Material changeover of the levers in the LMZFL product family

Type of notification: PCN PDN Short-term action

1. General Overview

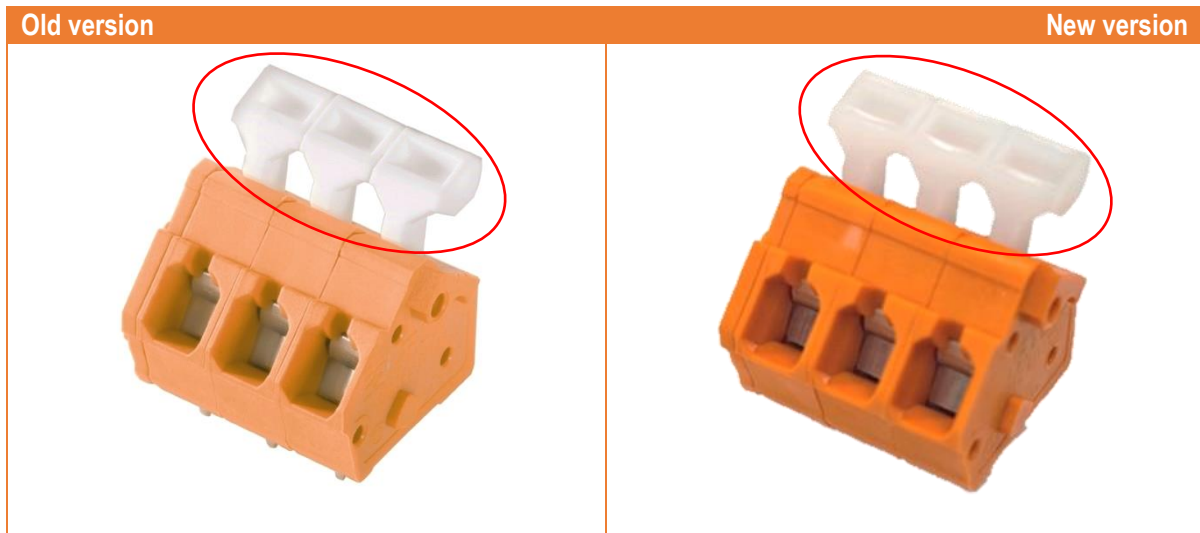
Due to a short-term supply stop of the plastic granulate PA66 V2 WT, the white levers of the new version are manufactured from the raw material POM HB AO. The raw material is listed with UL in the product approval.
